Palmdale Hybrid Power PROJECT

Responses to CEC Data Request Set 1 (1-88)

Docket 08-AFC-9

PALMDALE HYBRID POWER PROJECT (08-AFC-09)

Figure 5.7-5
Important Farmland in
the Vicinity of the Project
and Linear Facilities

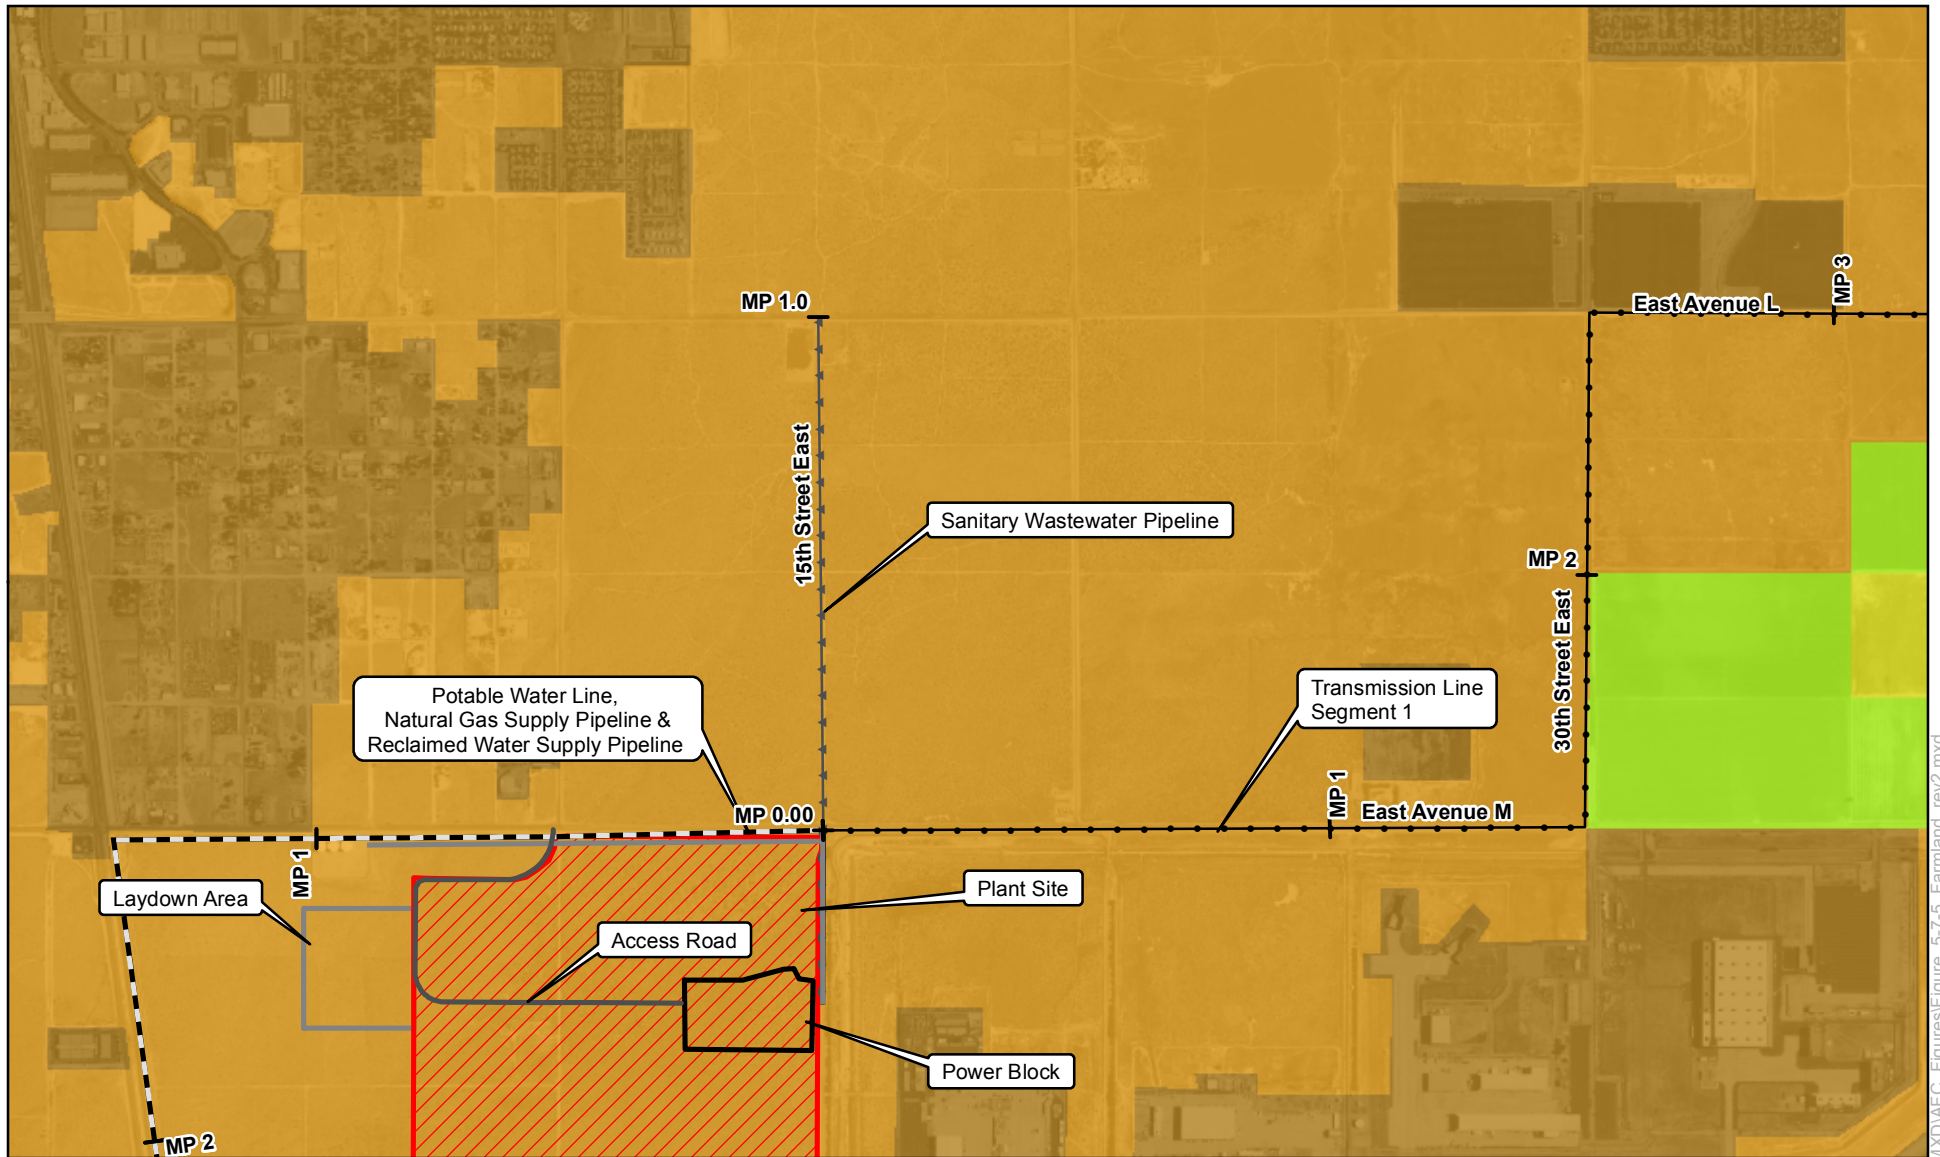
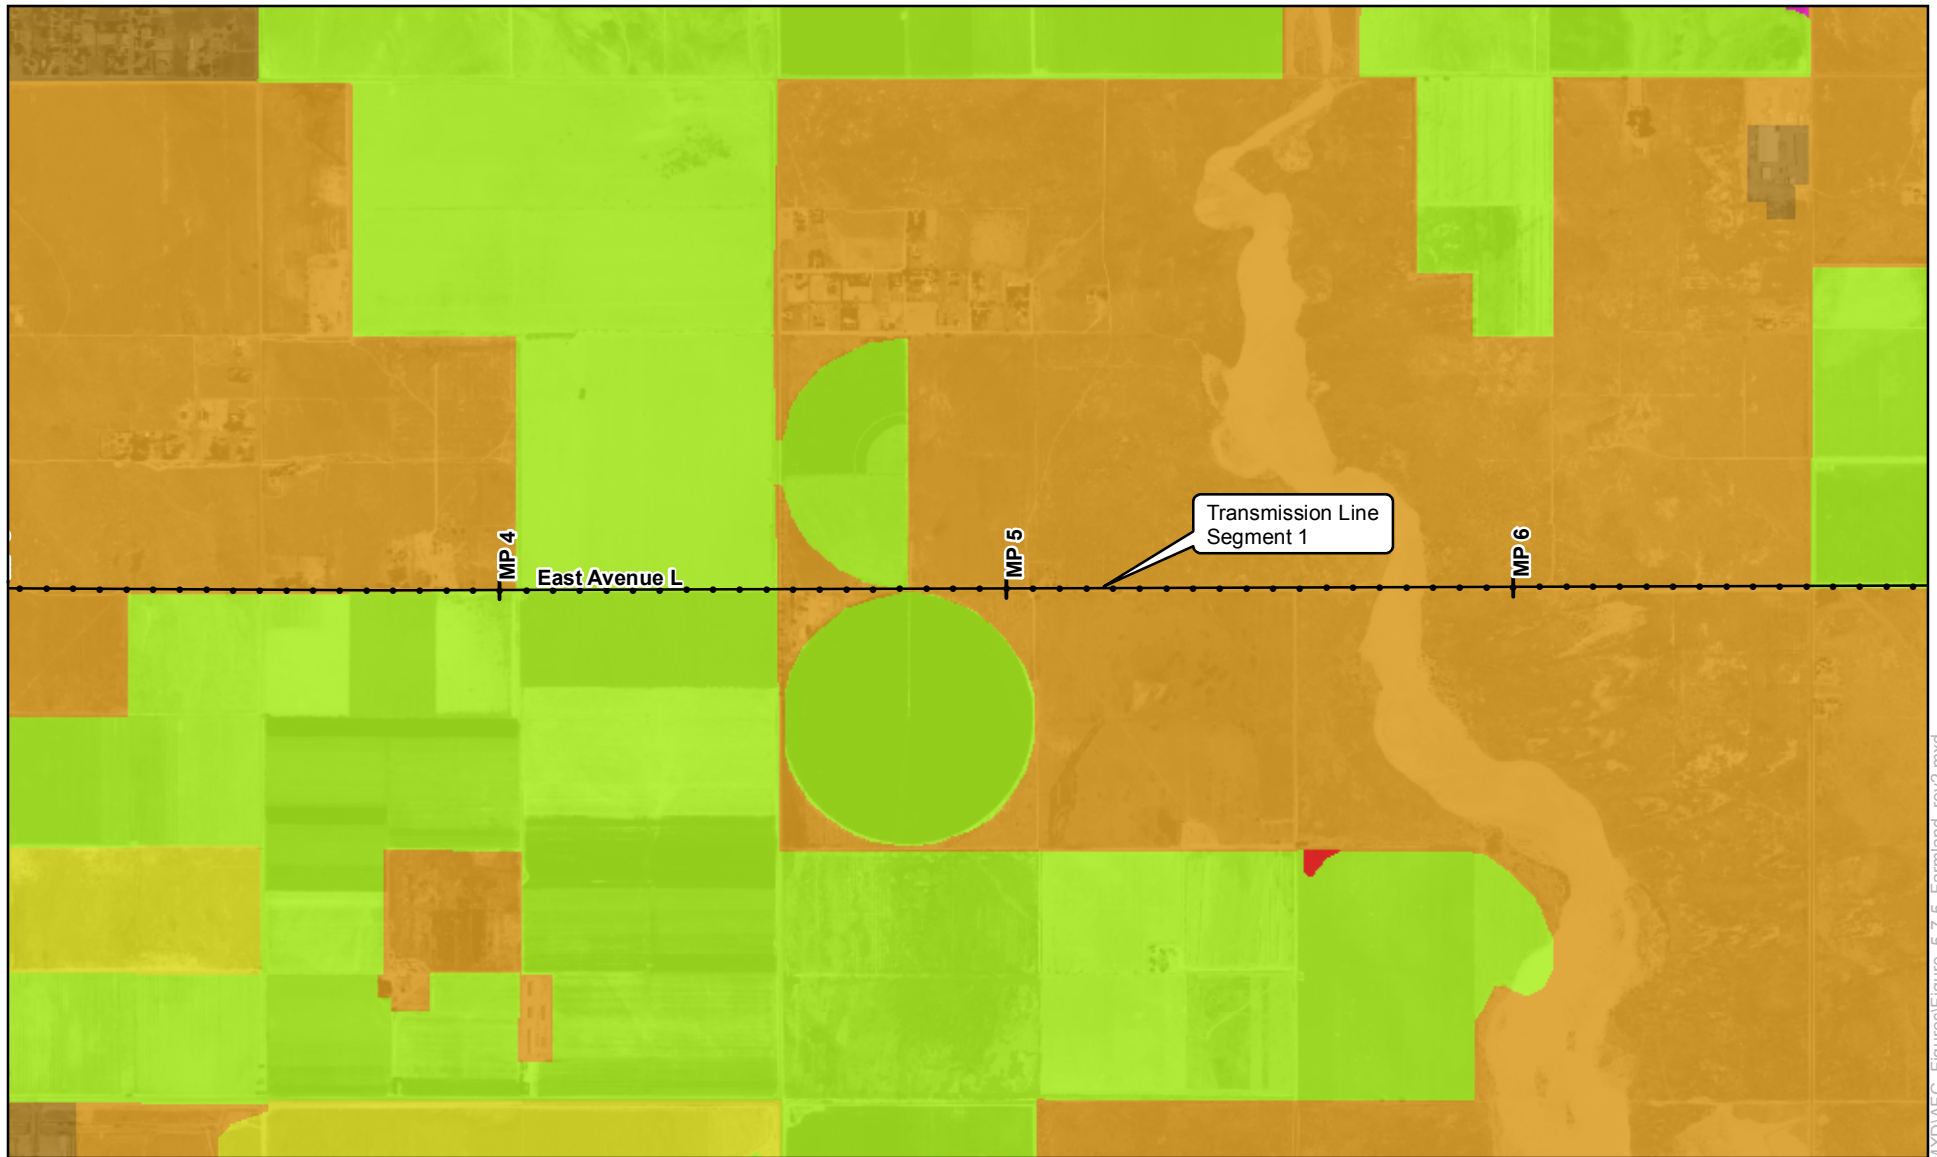
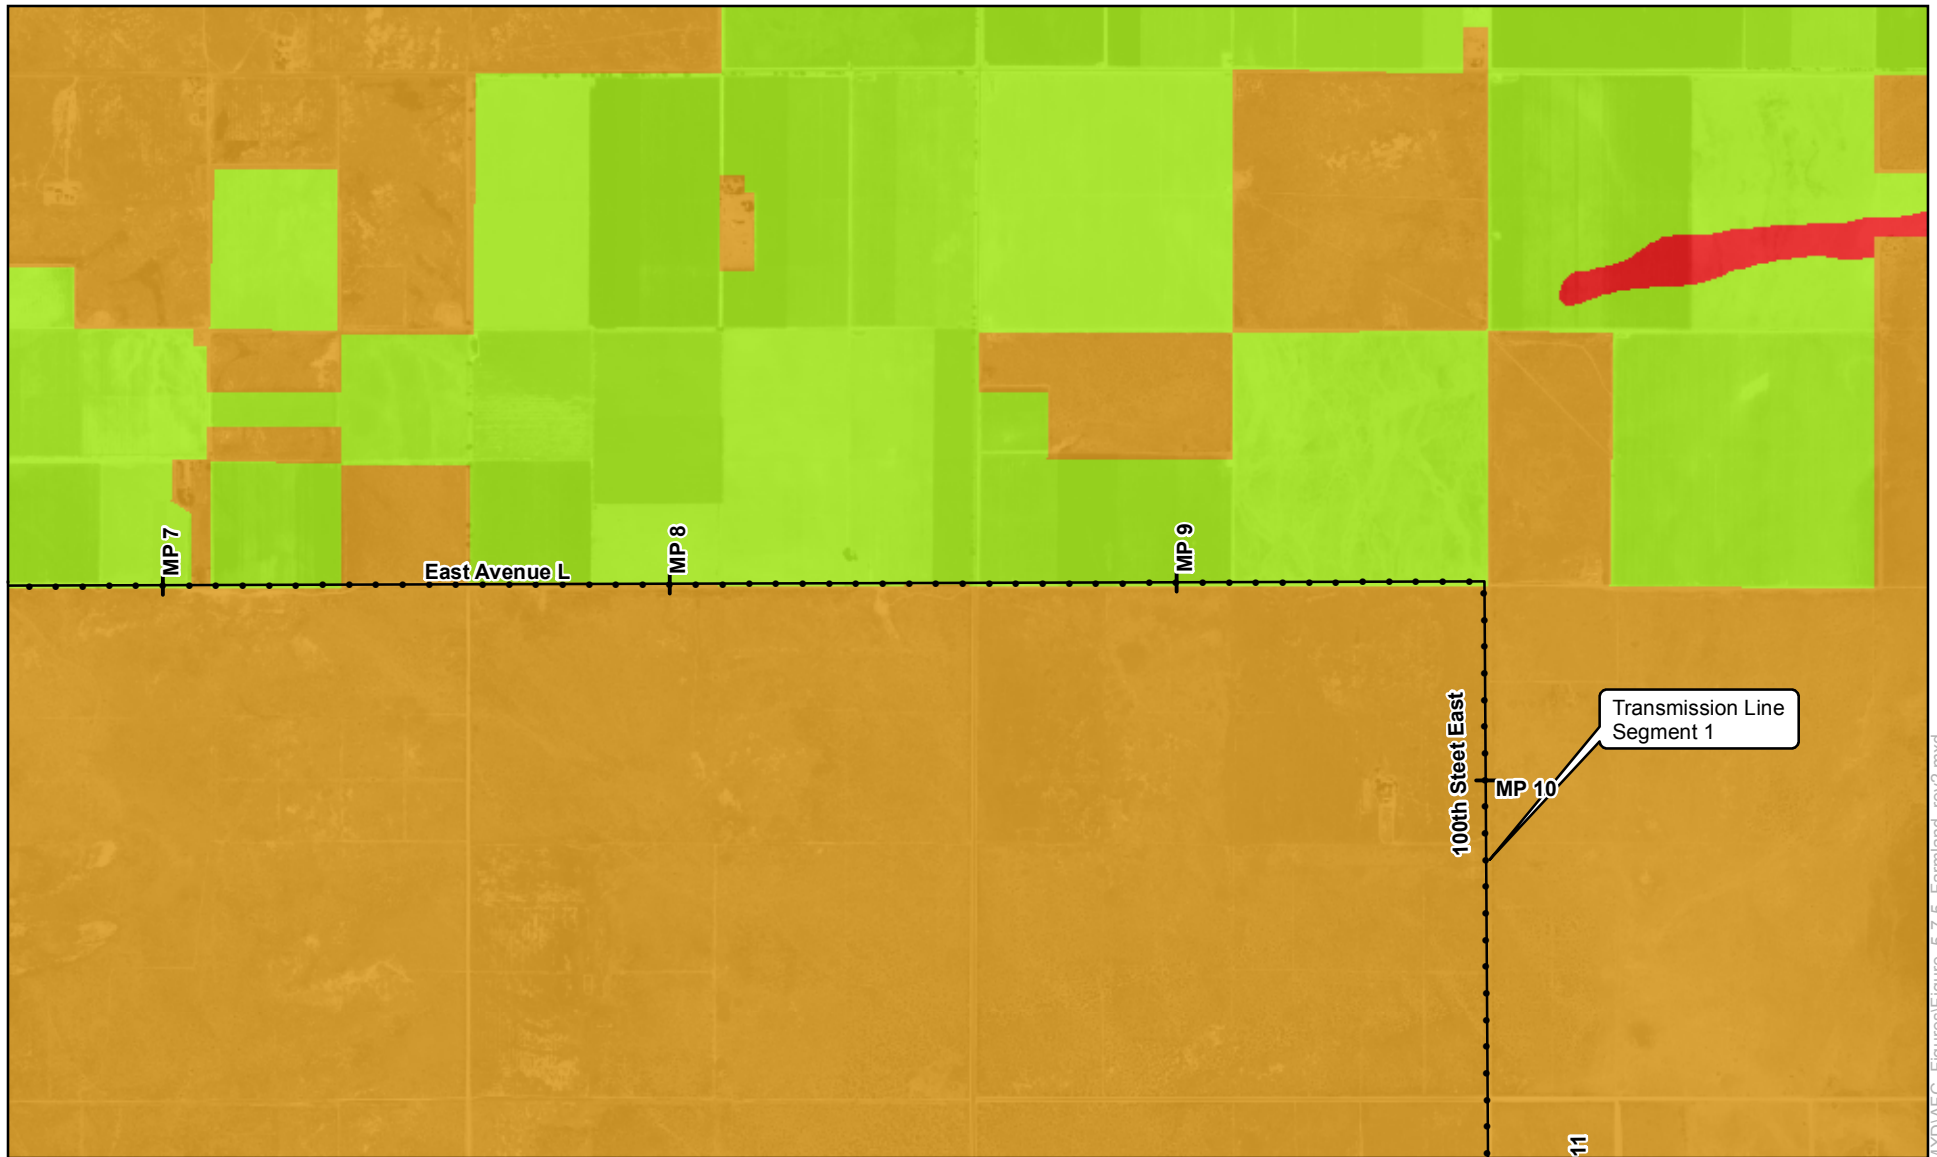
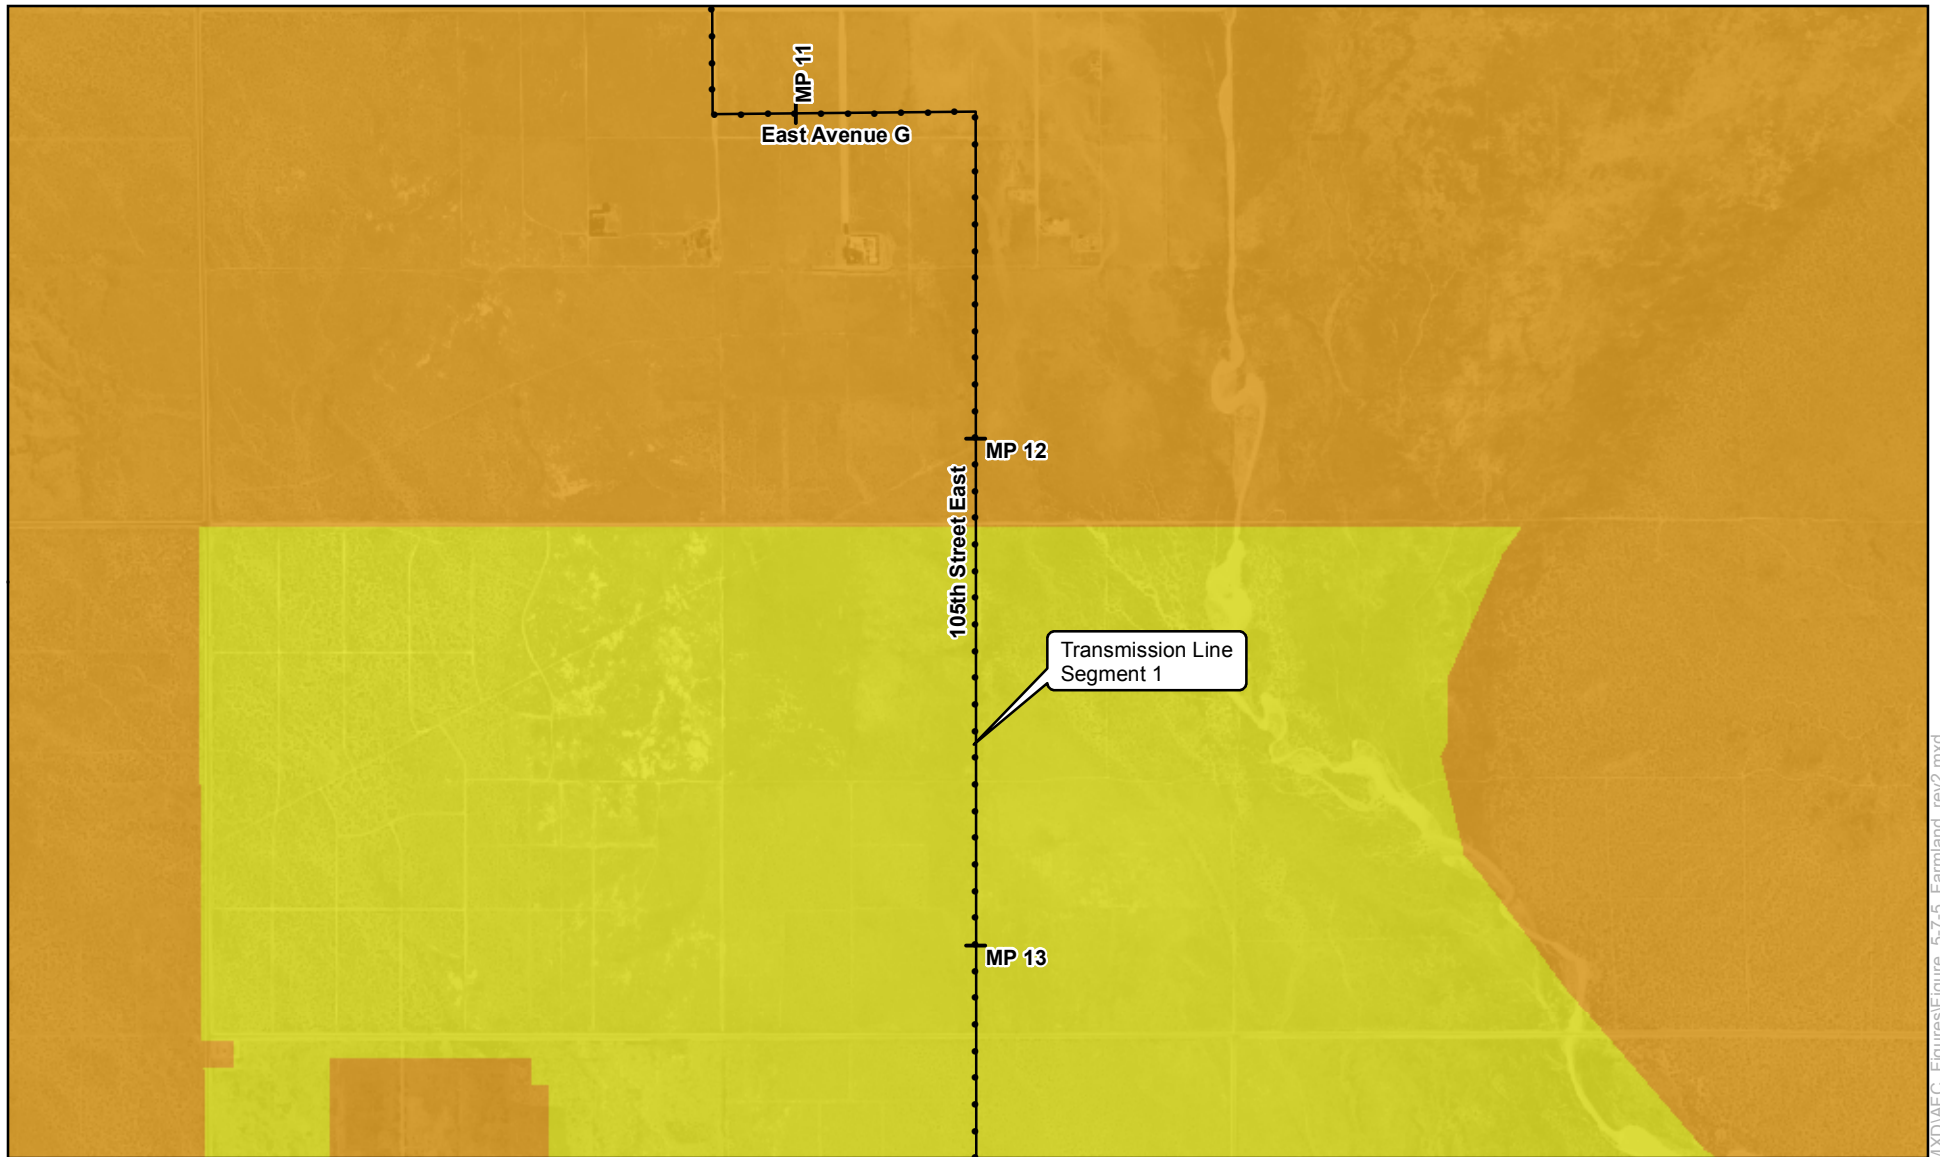
Please provide Figure 5.7-5 at an easily legible scale (e.g., 1 inch = ½ mile).

An updated Figure 5.7-5 is provided at the end of this section in an easily legible scale. The Figure, entitled "Important Farmland in the Vicinity of the Project and Linear Facilities" has been expanded to include 14 discrete mapsheets, each at 1:24,000 scale or one inch equals 2,000 feet.
